Stage 1 Road Safety Audit

South Circular Rd to Bishops Quay Cycle Lane, Limerick City

On behalf of Limerick City & County Council

September 2022

4.3.10 South Circular Road width to north of Lifford Park junction

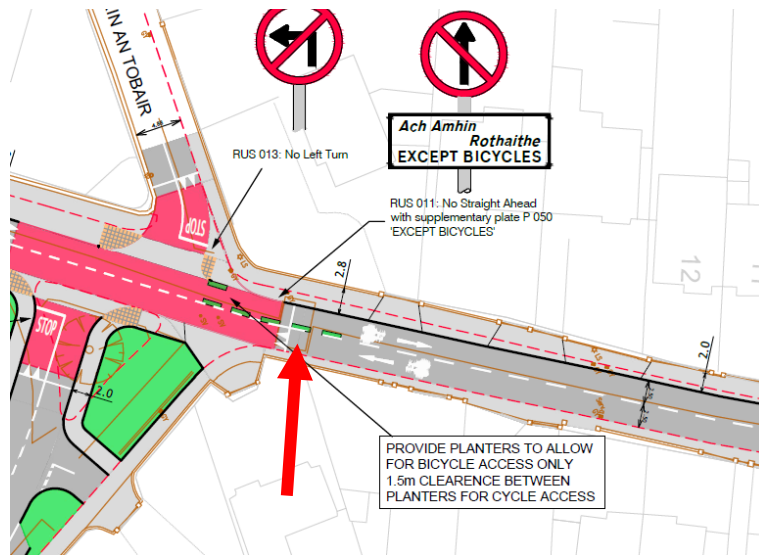
Problem: The proposed planters appear to be located in the middle of the road. No remaining lane width for southbound vehicles is indicated on the drawings.

Hazard: Large southbound vehicles may strike the planter and push this into the path of oncoming cyclists.

4.3.11 Scoil Mháthair Dé – Collection / Drop off

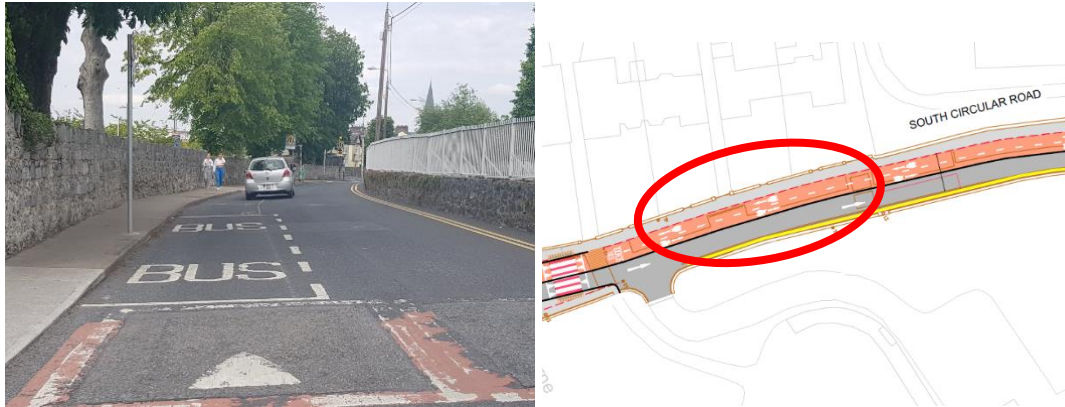
Problem: The proposals will reduce carriageway width near the entrance to Scoil Mháthair Dé. It is not known if this area is used for temporary set down for school collections / drop off.

Hazard: The reduced carriageway width may result in congestion in the area and traffic backing up on the roundabout junction. Rear end shunts may result.

4.3.13 Car Parking Bays to south of Naughton's Place and Clontarf Place

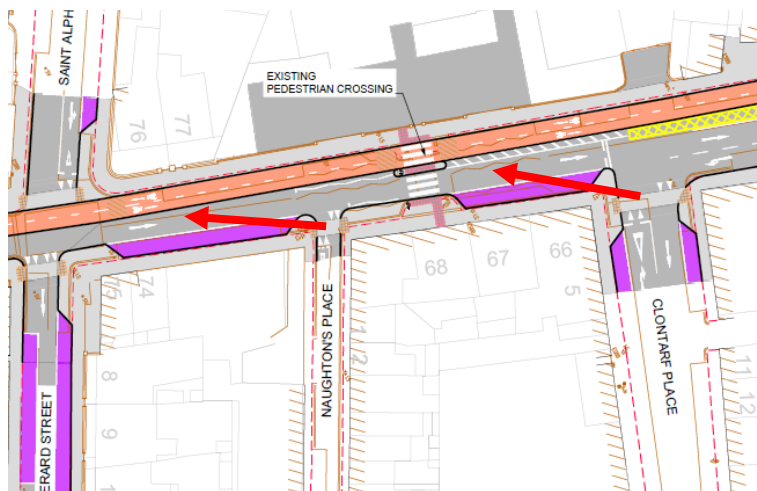
Problem: The car parking bays on Henry Street are close to the minor roads to the south.

4.3.14 Vehicles turning left into Clontarf Place

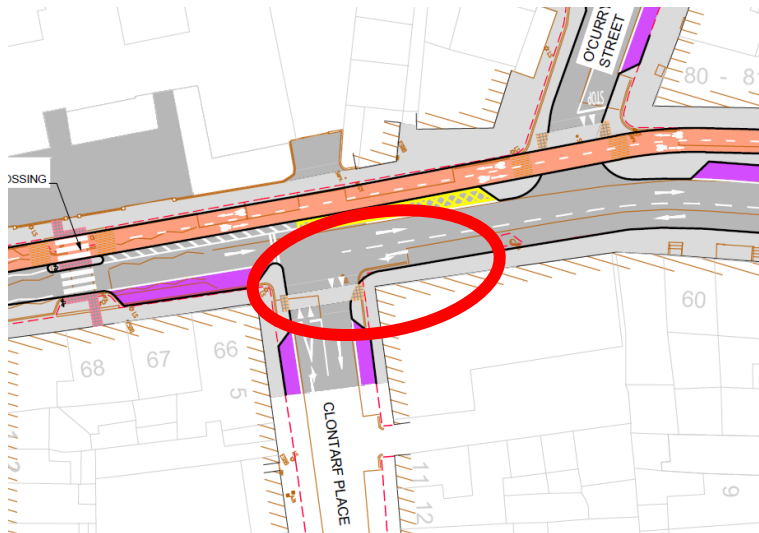
Problem: The footpath material carries through the side road junction, thereby implying the pedestrian has priority here, but there is no road markings requiring the motorist to yield to this pedestrian.

Hazard: Impact between motorists and pedestrians may result.

Recommendation: Provide suitable signage and road markings so the motorists is fully aware of their need to yield to pedestrians.

4.3.15 Car Parking Bays to west of Windmill Close

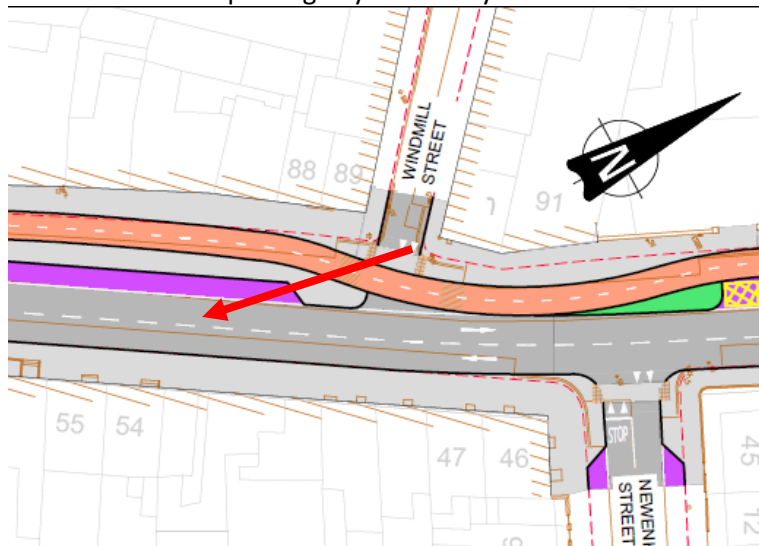
Problem: The car parking bays on Henry Street are close to Windmill Close

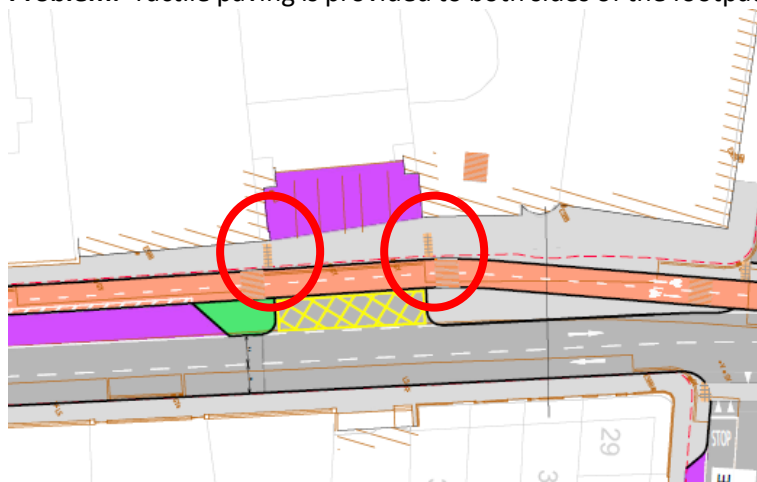
Problem: There are a number of car parking spaces to the front of the oriental supermarket. These users were observed driving forwards into the spaces and reversing back onto Henry Street. The provision of the cycle facility may result in the user reversing back over the cycle facility.

Hazard: Impact with cyclists may result.

Recommendation: Provide signage to encourage reversing into the parking spaces.

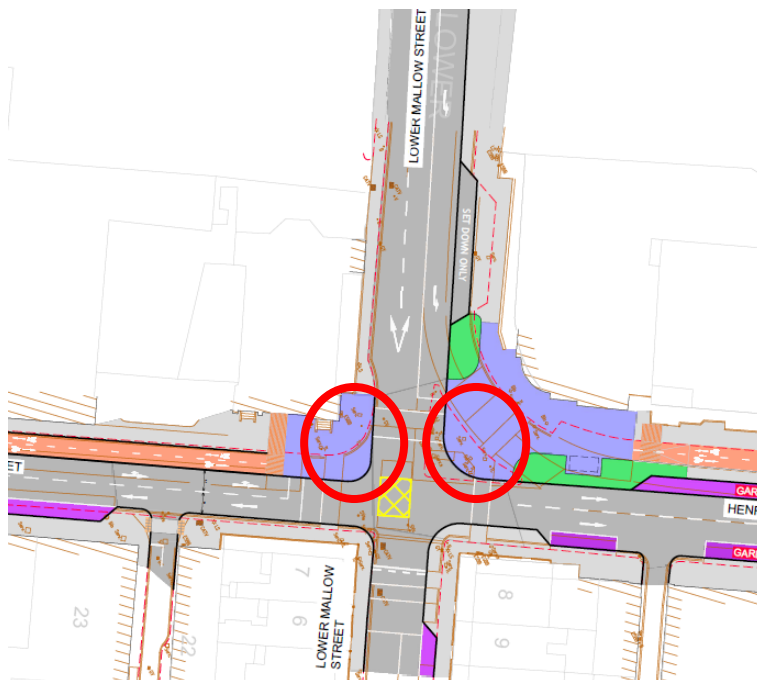
Problem: Substantial volumes of pedestrians were observed during the site visit in the area of Henry street / Mallow Street junction. The proposals indicate this area is to become a shared space for use both by cyclists and pedestrians.

Hazard: Cyclists are likely to depart the segregated cycle path at speed and enter the shared space. Impact with pedestrians may result.

Recommendation: Provide a means for cyclist to enter the main carriageway safely and incorporate cycle facilities within the signalised junction. Amend the layout to provide a footpath only over the area currently shown as a shared surface. Terminate the cycle facility at the commencement of the pedestrian area.

4.3.20 Mill Lane – Vehicle Cross Overs

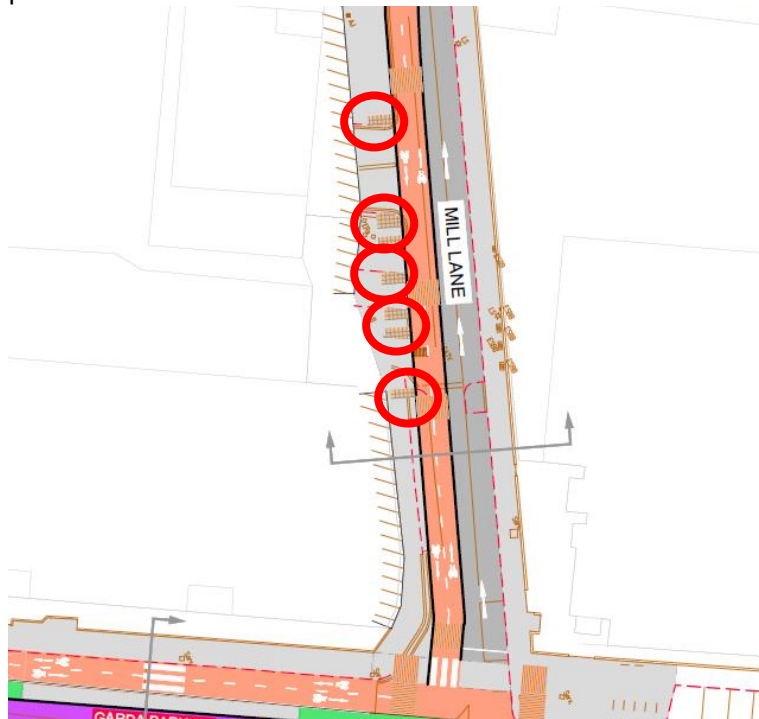
Problem: There are a number of tactile paving sets shown along the footpath of Mill lane at the private entrances.

4.3.21 Lower Mallow / Henry Street Junction Option 2

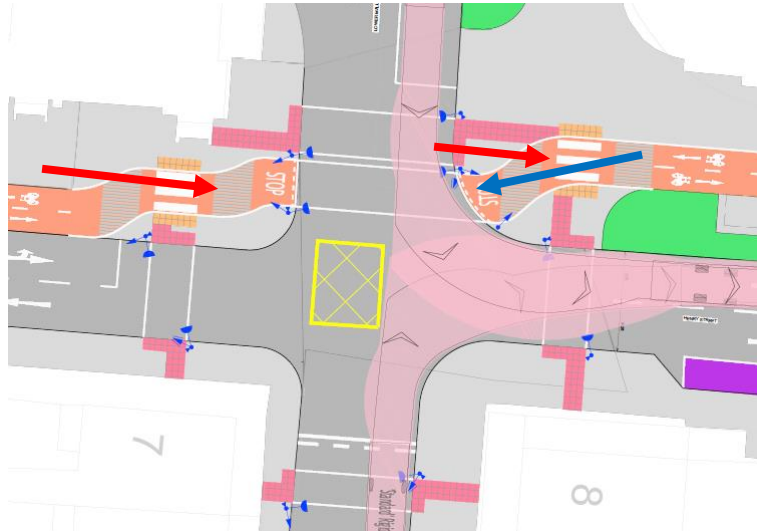
Problem: The cycle path incorporates a number of sharp changes in direction

Recommendation: Provide a uniform and straighter alignment that is more self-regulating and not in the direct line of pedestrians.

4.3.22 Lower Mallow Street / Henry Street - Pedestrians

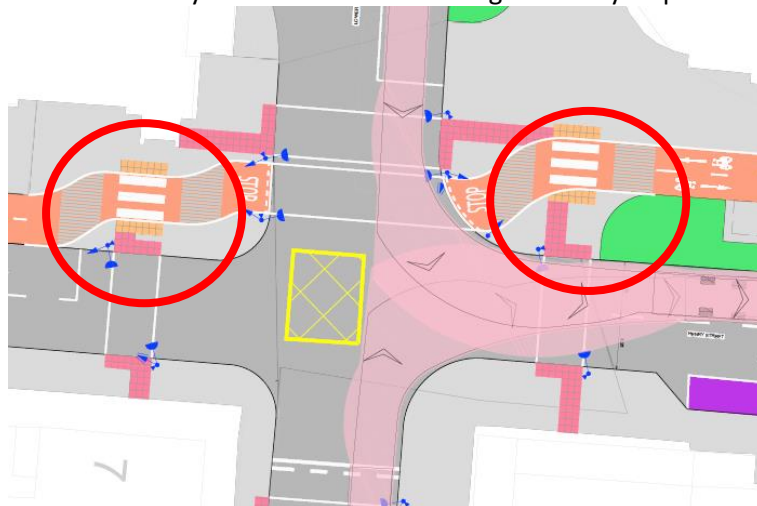
Problem: Signalised crossing points are offered to the pedestrian for crossing the main carriageway, but there is only an uncontrolled crossing for the cycle path.
